SERVICE BULLETIN

TS-940S PLL UNLOCK 4-8-86

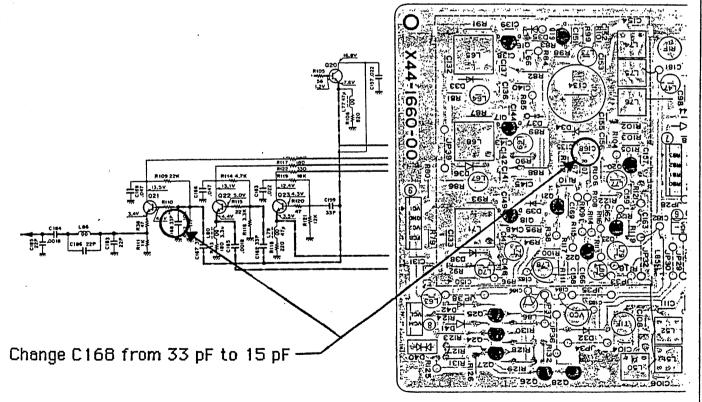
Reports of a PLL Unlock on the lower frequencies may be due to low VCO levels. The following change will increase the VCO level and should prevent reoccurance of this symptom.

C168.....change to 15 pF 50 y (CC45SL1H150J)

- On the RF Unit (X44-1660-00) change C168 from a 33 pF capacitor to a 15 pF 50 v capacitor.
- 2. Readjust the VCO BPF (RF unit L74-76) according to the instructions contained in the TS-940Sservice manual.
